Figure 22: Typical mid-rise vertical village infill

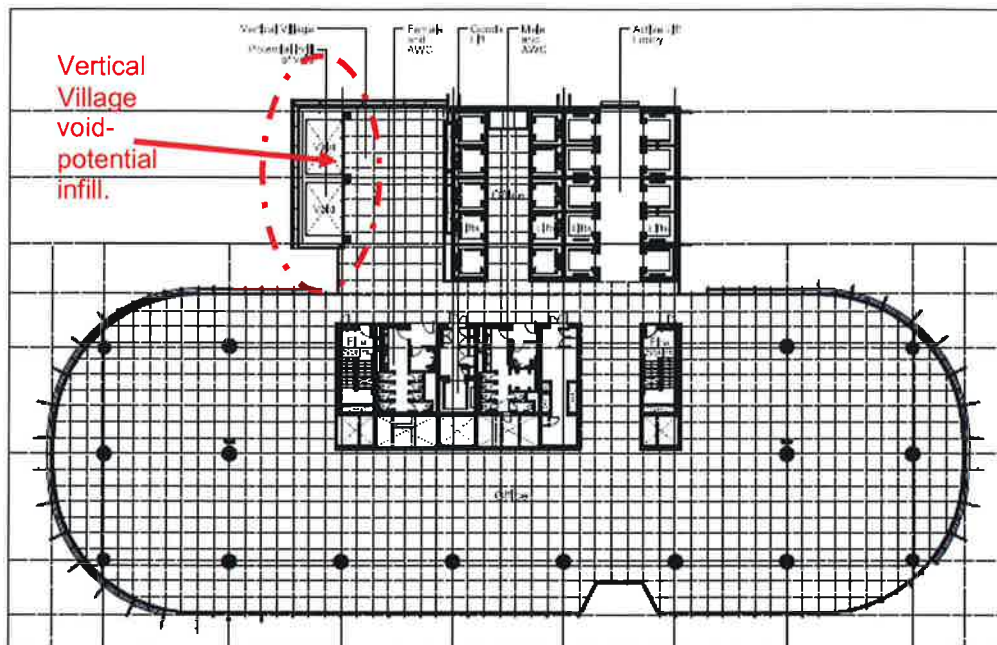
The Proponent has confirmed that there are twenty vertical villages within the building, each with a horizontal area of 56 sqm. Mod 3 seeks approval to infill up to ten of these voids which would equate to

560 sqm of additional GFA. A typical detail for the vertical village through the mid-rise and the high-rise of the tower are illustrated in **Figures 22** and **23** below.

The Department has considered the potential impact of the proposed amendment on the design quality of the commercial tower. The Department notes that a key design feature of the C3 (and other towers at Barangaroo) is to maximise tenant flexibility by providing floor plates which can accommodate best work practices, including to allow for inter-floor connections of vertical villages. Whilst the infill of the void will have minimal impact of the overall design quality of the commercial tower, the Department recommends that the infill of the voids be undertaken in a fully reversible manner so that the flexible design intent for the vertical villages is not eroded. This approach would be consistent with the Department's approach for C5 which also included provision for the potential infill of the vertical villages. The Department has recommended a condition to address this matter.

Further to the above, and in order to account for the potential increase in the GFA associated with the infill of the voids (and other minor adjustments to the overall building GFA as a result of the refinement of the design), the Proponent proposes to adjust the maximum permissible GFA in the building from 117,968 sqm to 118,959 sqm (or an overall increase 991 sqm). Condition A1 of the project approval requires that the total maximum GFA of the building not exceed the stated GFA. For this reason, the Department is satisfied that the condition will provide Lend Lease with the flexibility required to accommodate tenant requirements whilst requiring compliance with the nominated GFA specified in Condition A1.

Figure 24: Ground Floor landscape plan show location of temporary bicycle parking (source: Aspect I Oculus)

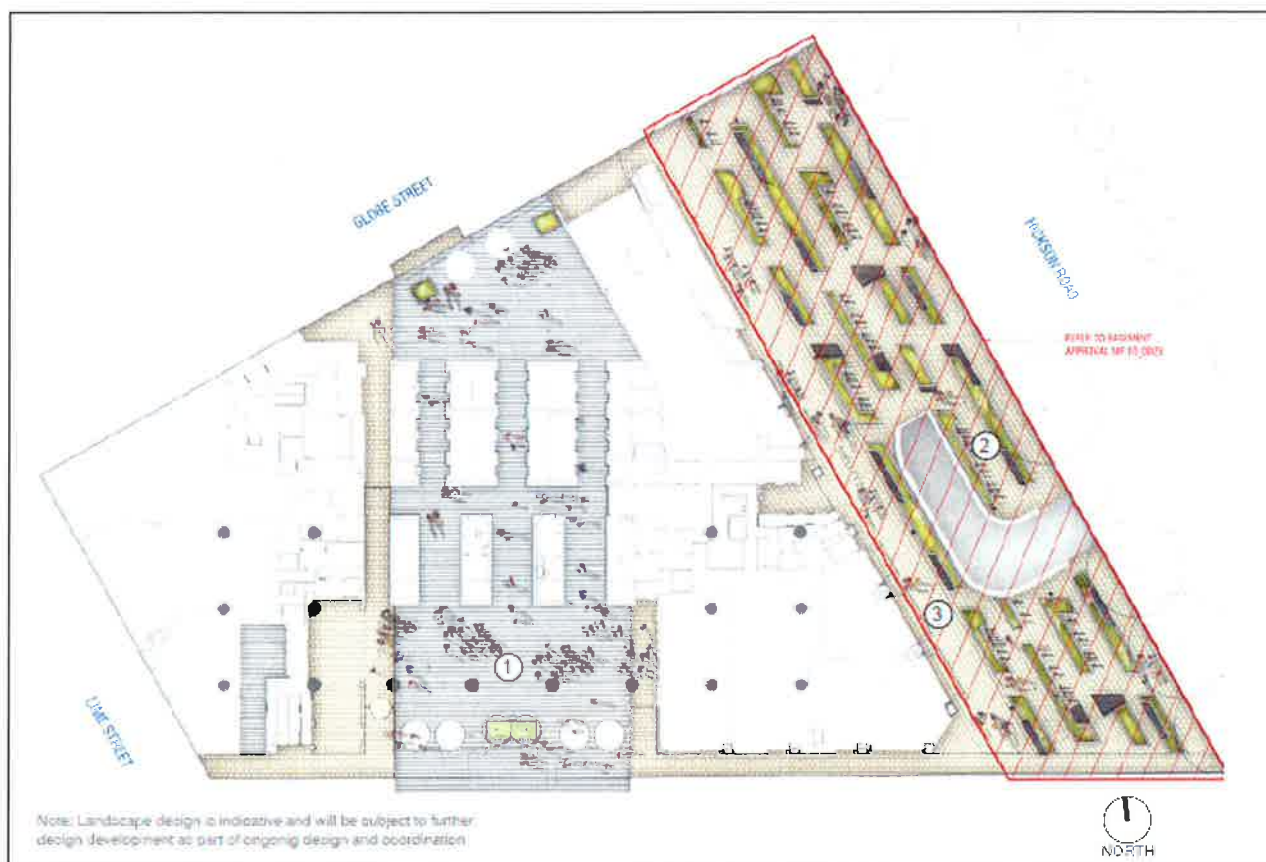
The total approved bicycle parking for the development is 373 spaces comprised of 336 spaces permanently located within the basement carpark and 37 spaces which are located within the temporary landscaped forecourt fronting Hickson Road on a future development site referred to as 'C1'. MOD 3 seeks approval to modify Condition B23 to clarify the circumstances under which the temporary bicycle space would be provided. In this regard, MOD 3 proposes that the temporary bicycle parking would only be provided in following circumstances:

The location of the temporary bicycle parking is illustrated in **Figure 24** below.

MOD 2 establishes that 37 visitor bicycle spaces be provided within the temporary landscape courtyard adjacent to the Hickson Street frontage of the site. This is consistent with the approach also taken for C4 and C5 and is intended to temporarily activate the land to the east of commercial buildings prior to the development of these sites. Whilst these spaces will form part of the total bicycle spaces required to service the site, the Department notes that the public domain areas surrounding C3 have always intended to be temporary, and that the permanent visitor bicycle spaces would be constructed as part of the permanent public domain works. This being the case, the Department raises no objection to the proposed modification to Condition B23.

Figure 25A: Approved Signage zones
North Elevation MOD 2

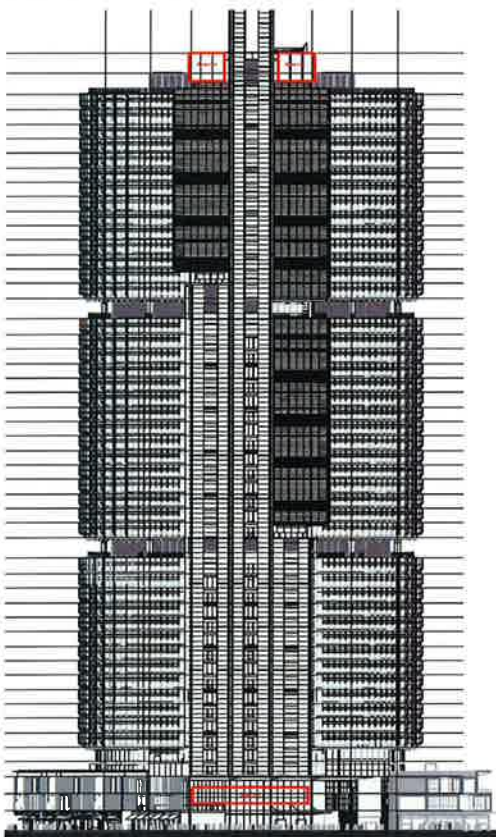
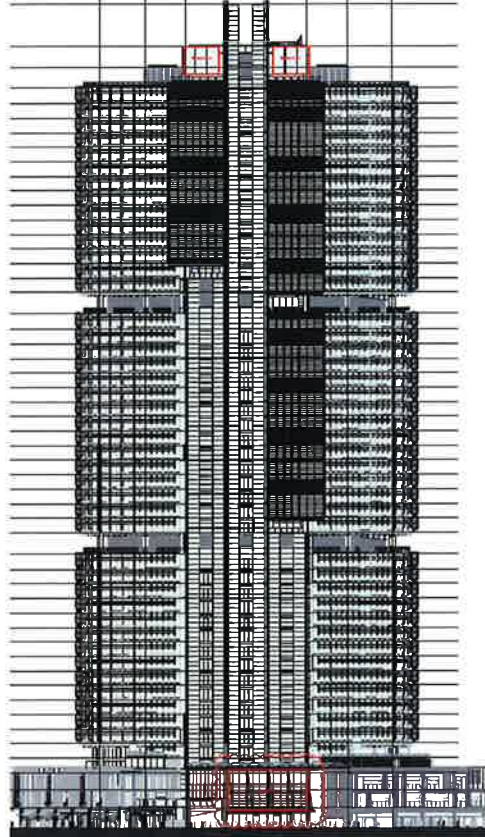
MOD 3 seeks approval to increase the area of the signage zones on the northern and southern elevations of the podium to provide greater flexibility. The maximum area of signage within the signage zones is not proposed to be modified. The Department notes that MOD 3 does not seek to change the four primary signage zones approved at the roof level of the building or the retail signage.

The changes to the building identification signage zones on the northern and southern elevations of the podium are illustrated in **Figures 25** and **26** below.

The Department considers that the change to the extent of the signage zones to be acceptable and to be an appropriate response to the architectural composition of the podium. Given MOD 3 does not seek any change to the size or number of signs within the modified signage zones and given the signage within these zones is restricted by the terms of the current project approval, the Department supports this aspect of the application.
